ADDENDUM

Project: PSC Fire Alarm Upgrade

Project No.: 23-131

Addendum No.: 1

LARSON - BASEMENT
FIRE ALARM - NEW

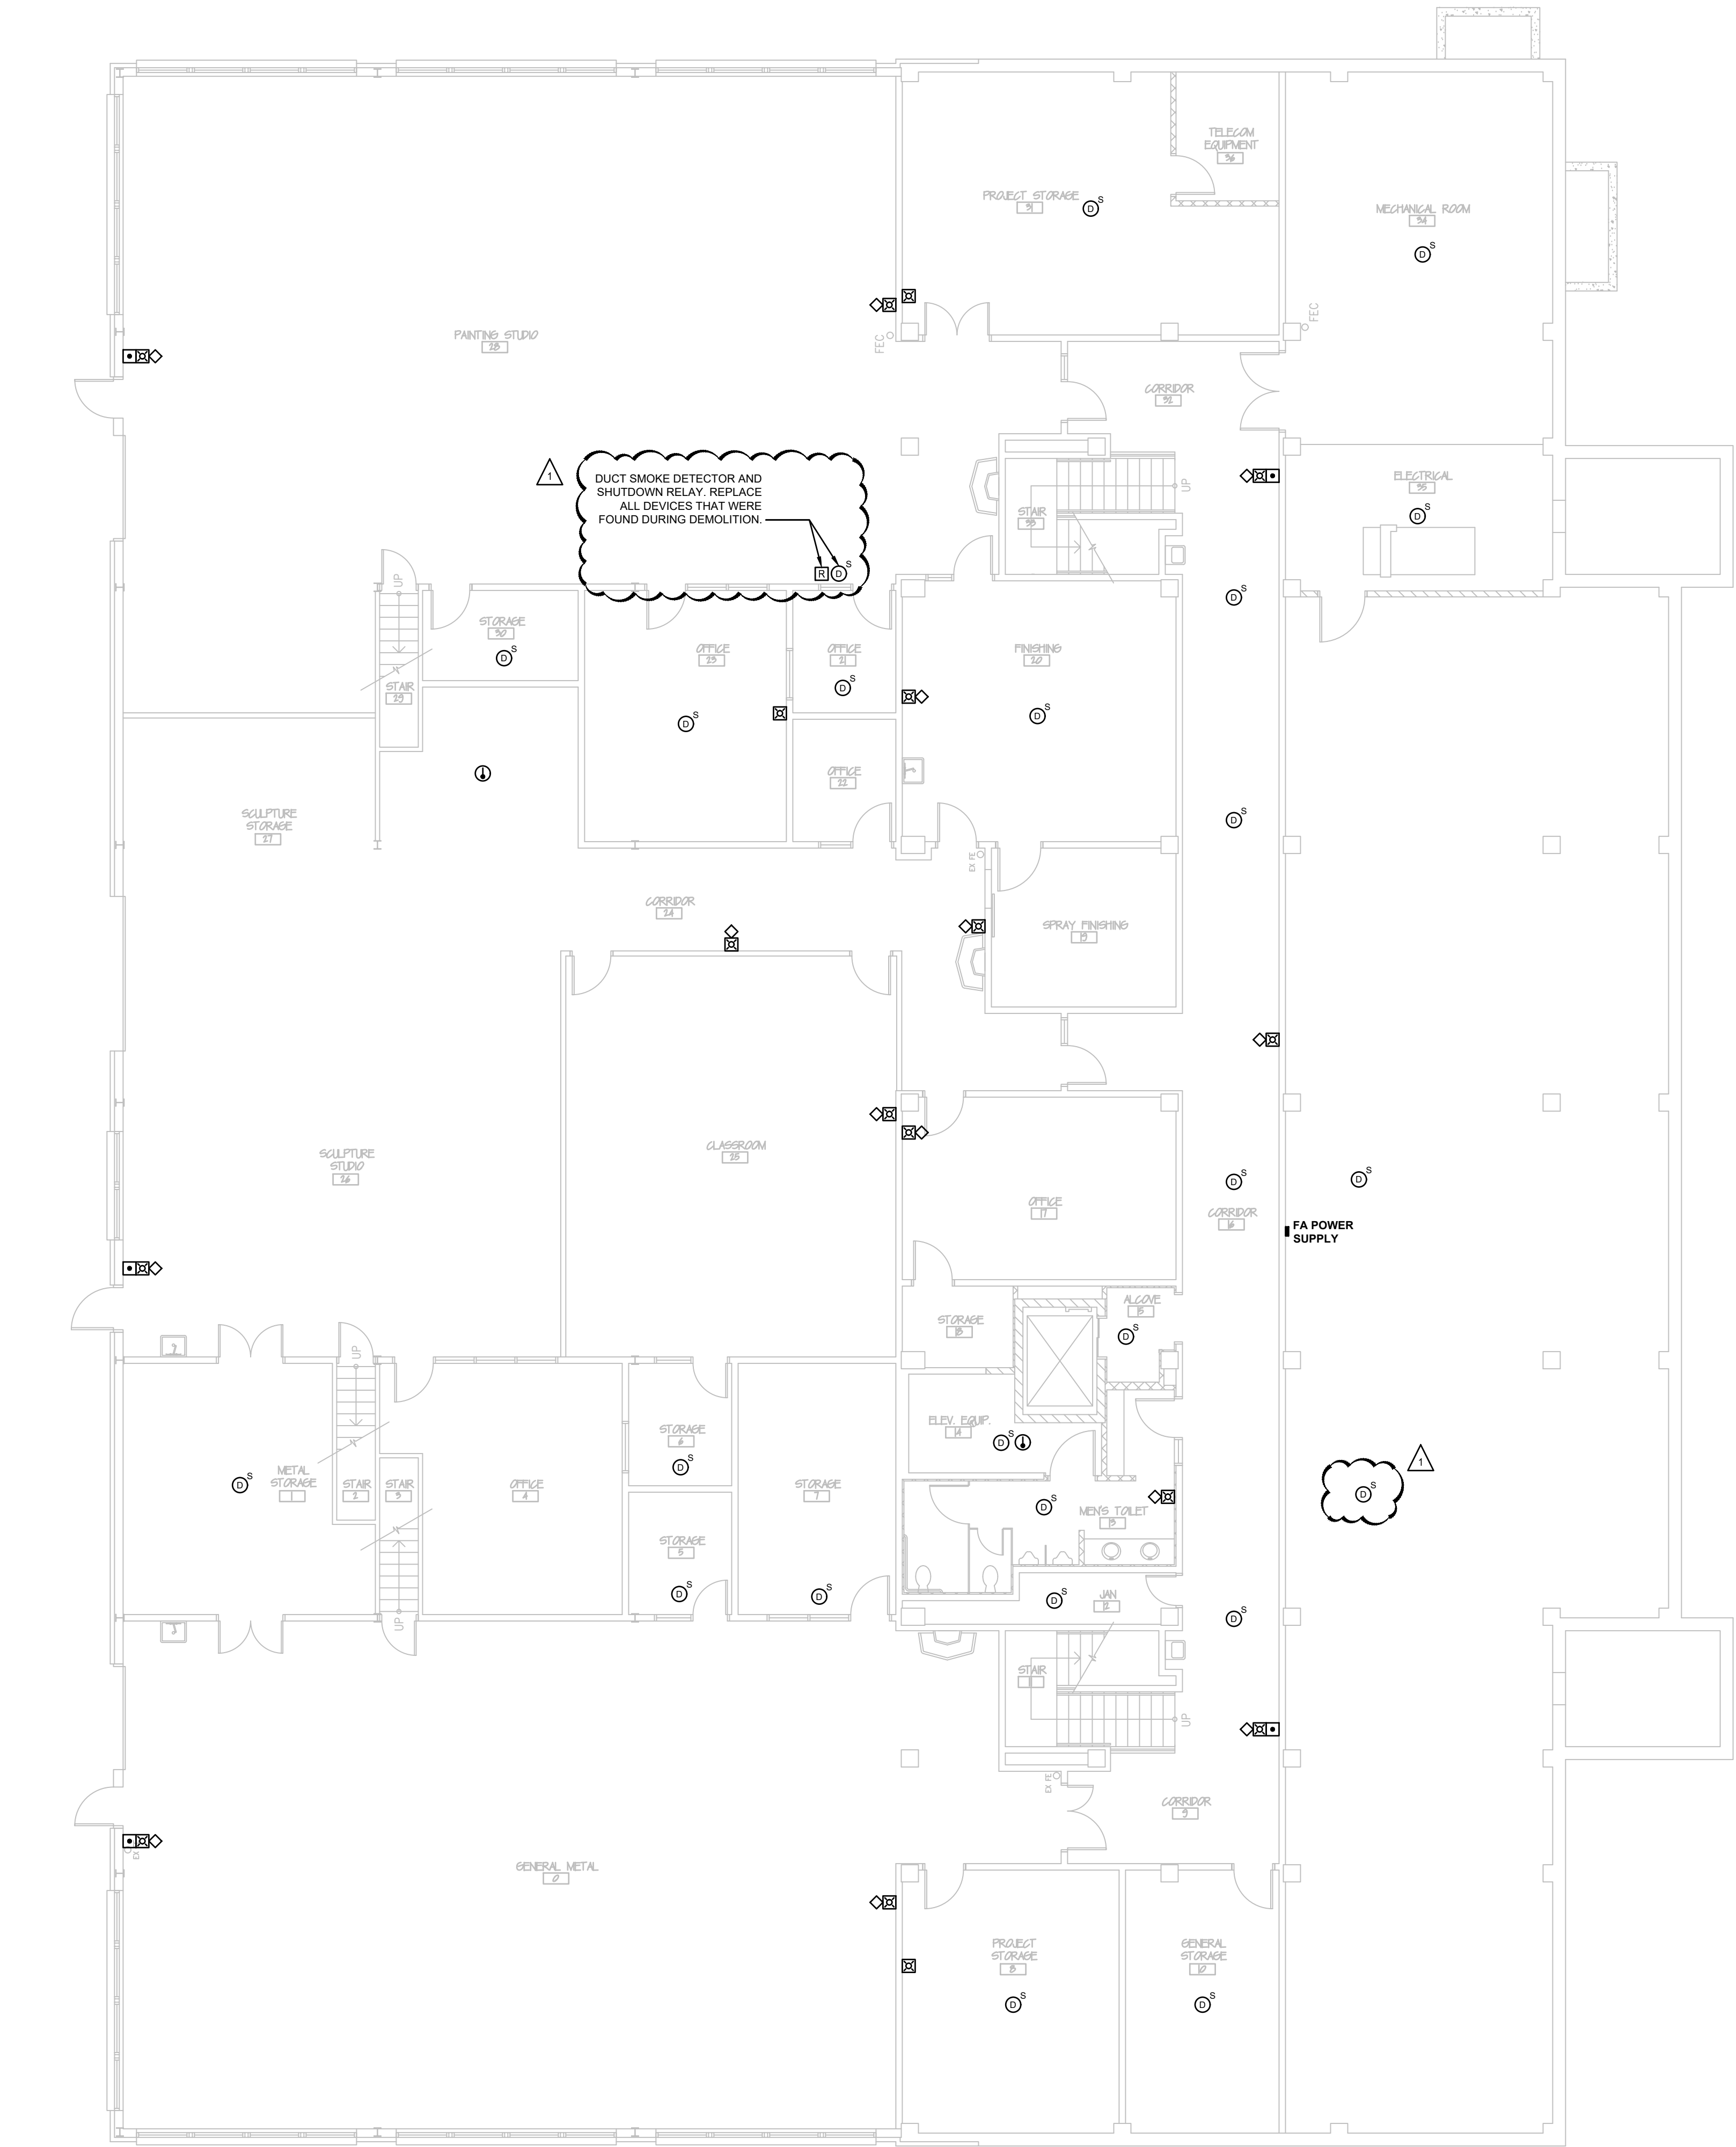
1. Added duct detectors.
2. Added smoke detectors.
